FOR PERCOLATION TESTING AND SITE EVALUATION

RE: **Percolation Test Results**
Application: A520028
Property ID: Subdiv: Woodmark, Lot 9
Tax Map: 22 Parcel: 168

Re: Percolation Test Plan Proposal
Mount Albert Road
Tax Map: 22 Parcel: 168

| TITLE: PERCOLATION CERTIFICATION PLAN | | | |

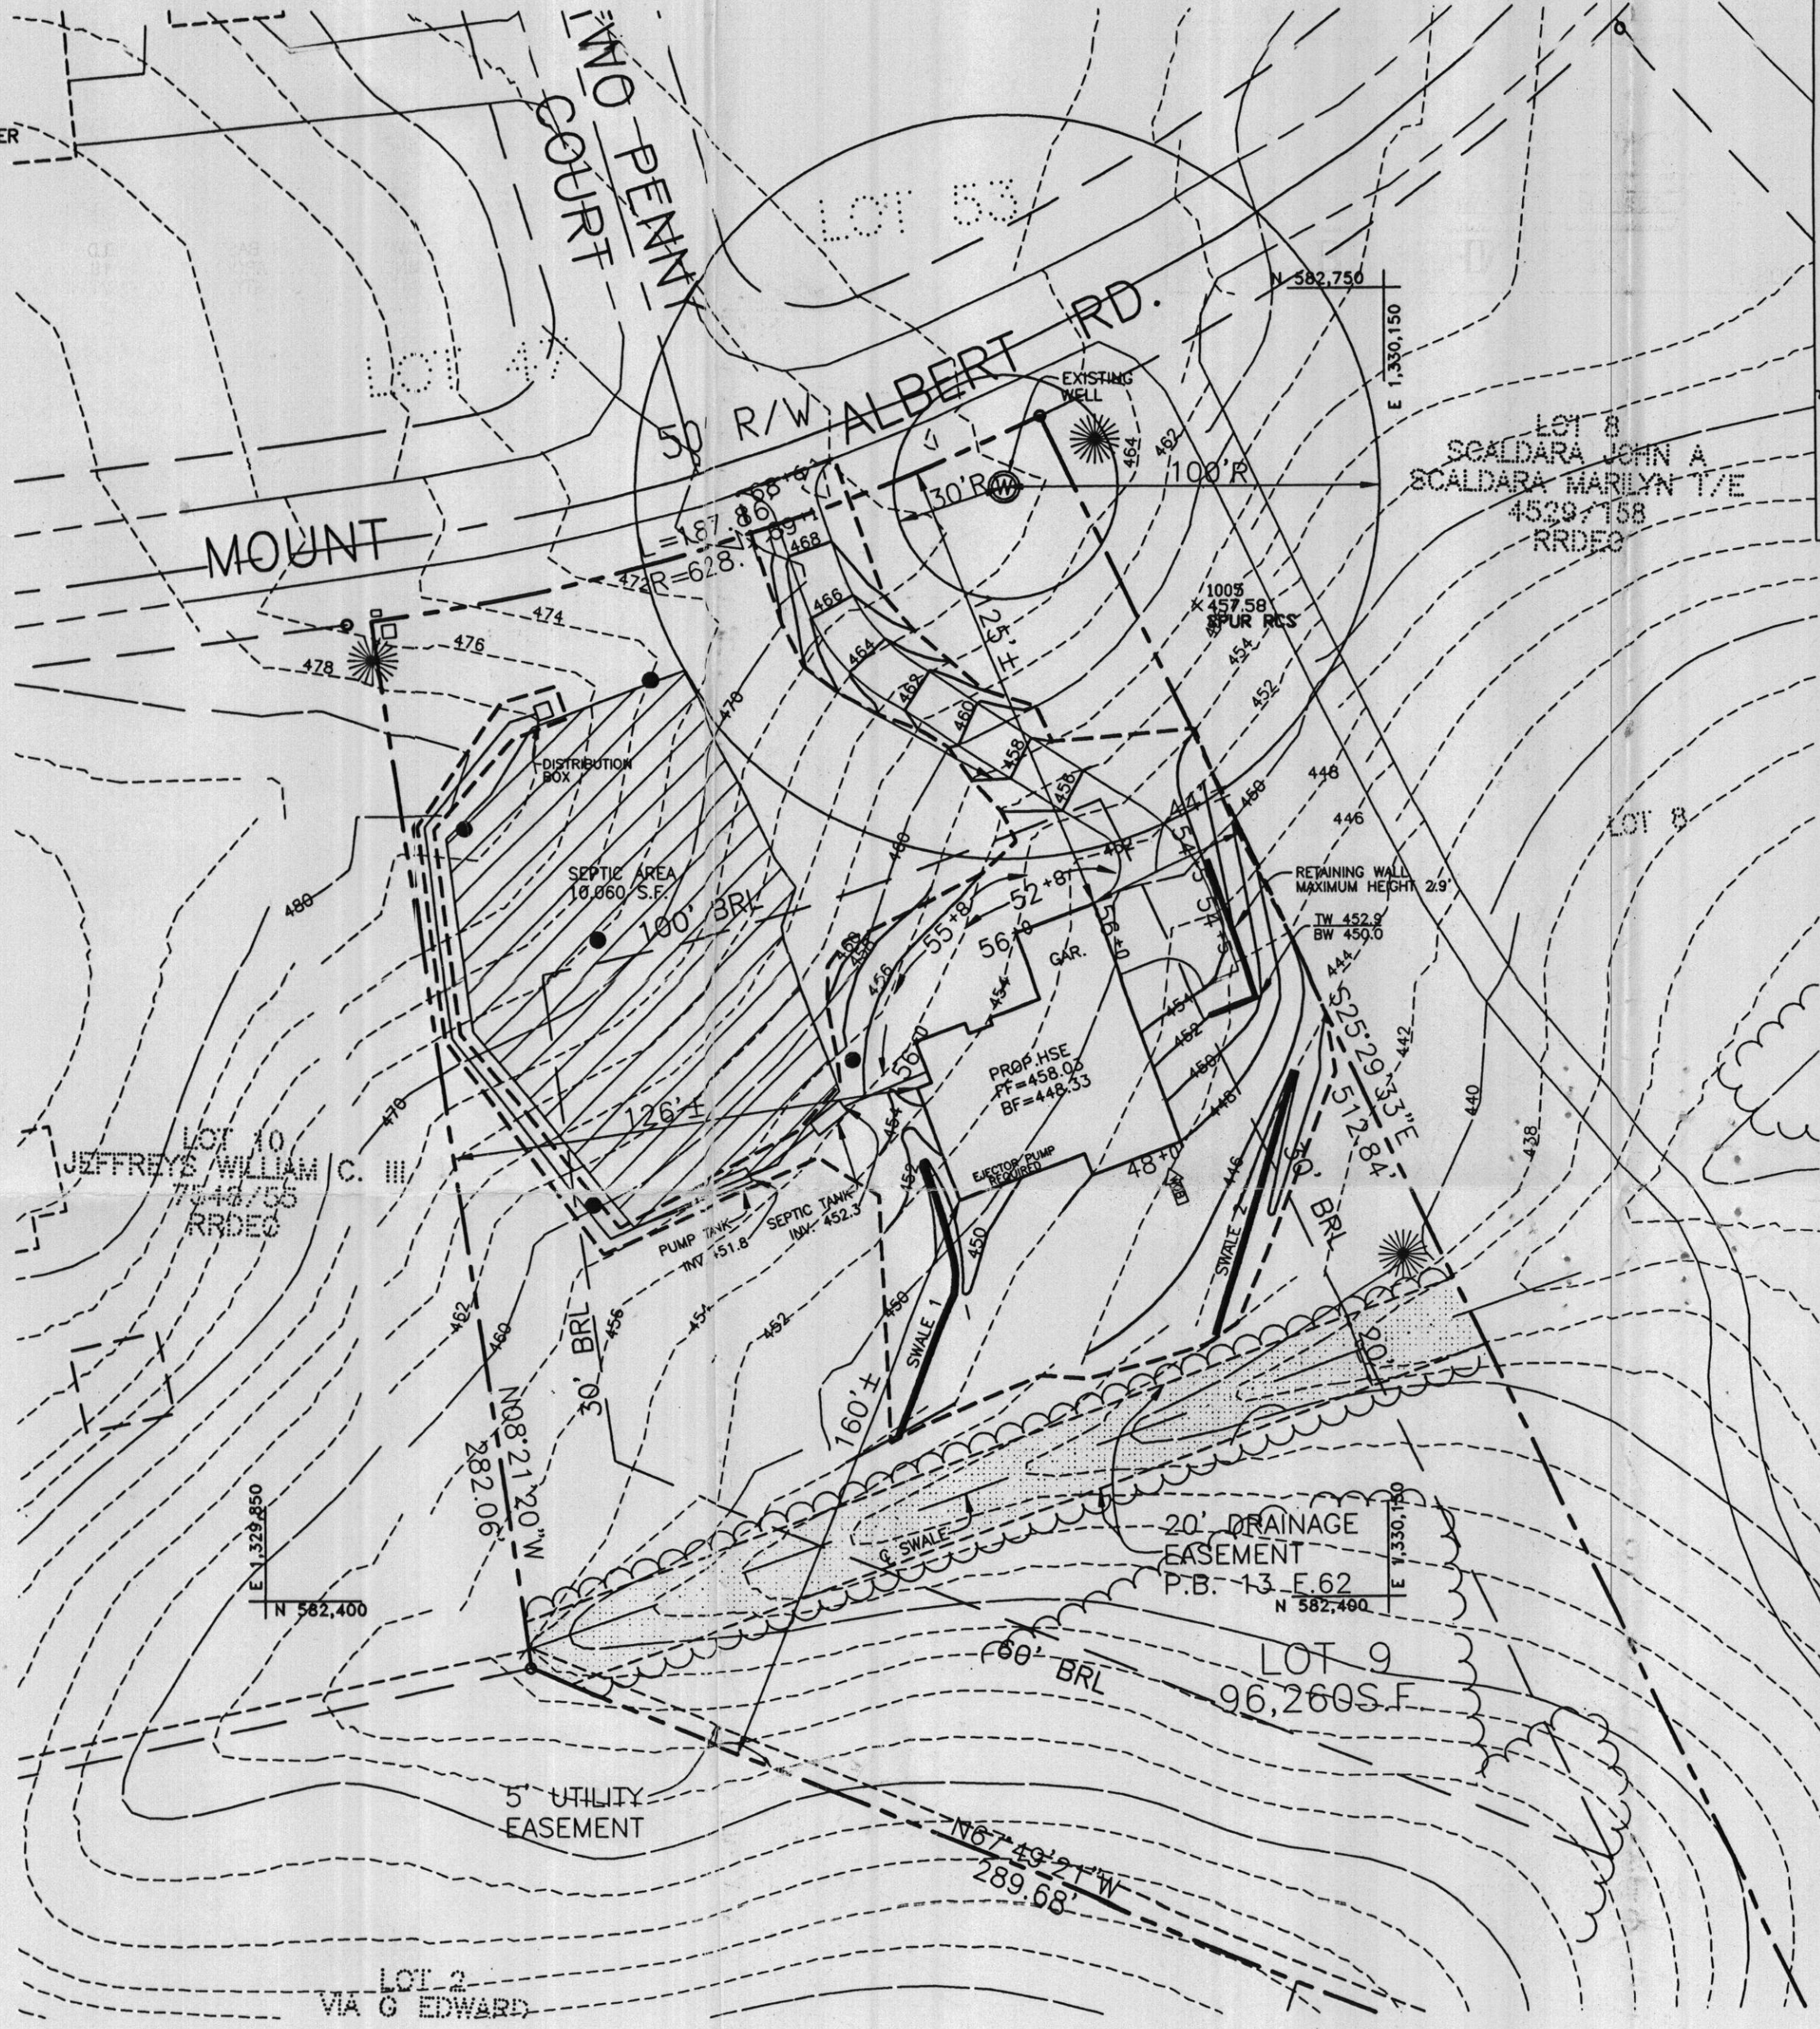
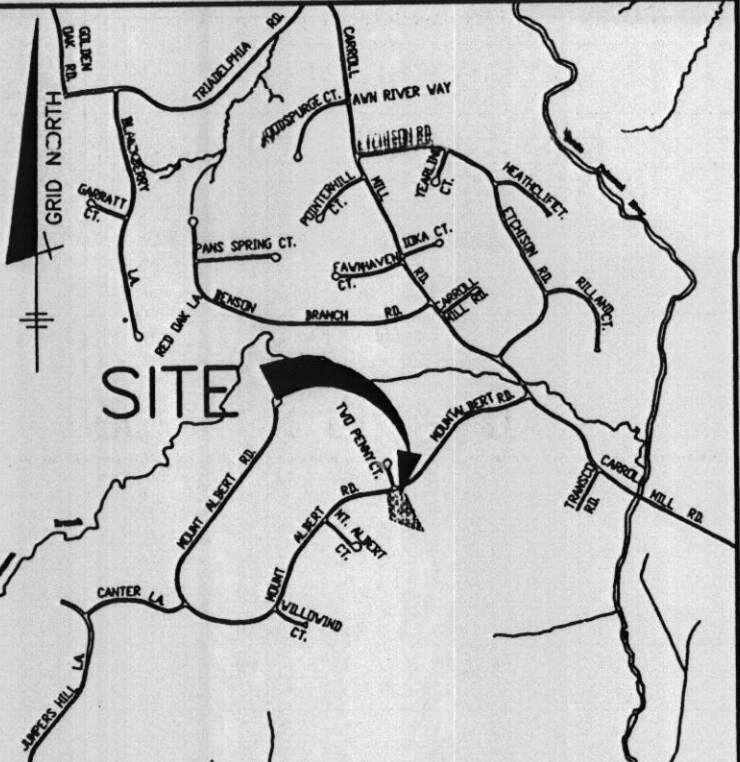
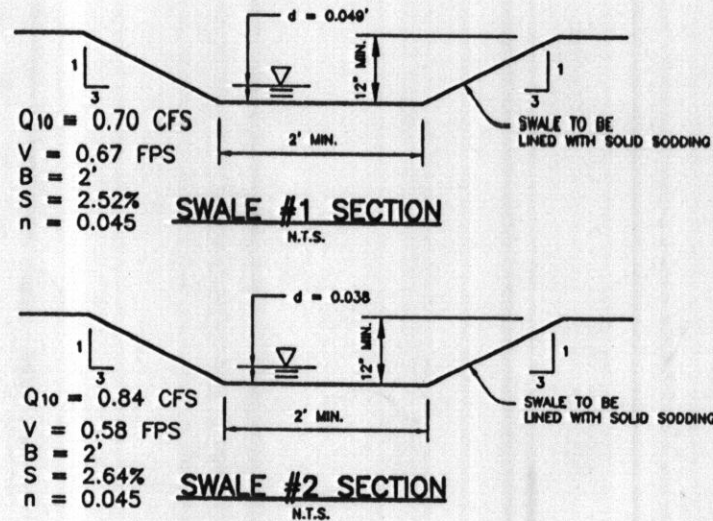
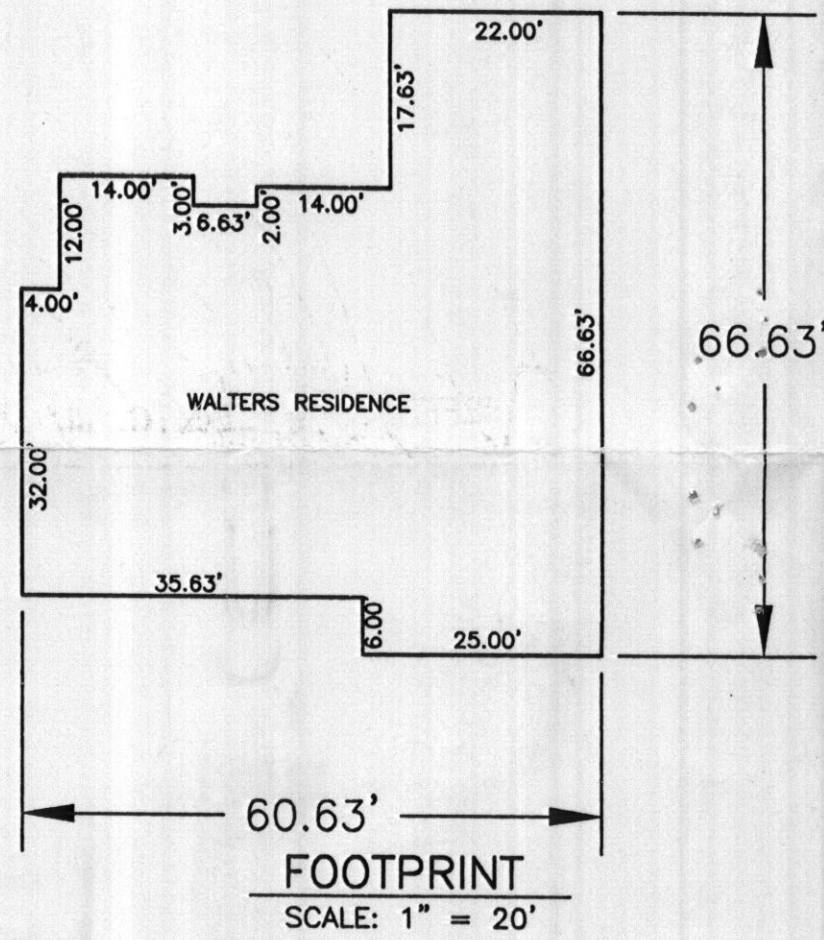
This office received the above referenced plan for preliminary review prior to percolation testing. A percolation test date cannot be scheduled due to changes necessary for the percolation test plan proposal. On February 2, 2004 a site inspection was conducted, and identified the following errors:

- Swale identified on plan appears broader and more prominent, and further west than shown on plan
- Although topographical features appear correct for the adjacent lots, the northernmost side of the property is not shown correctly
- The "drainage easement" is actually a stream with steep, eroded banks and must be labeled as a stream

Due to the existing swale running through the proposed septic easement and the proposed septic disposal area not meeting the 100' setback requirement from the stream, the plan is not approvable at this time. Further progress and review is dependent upon the submittal of an approvable percolation testing plan meeting the COMAR regulations.
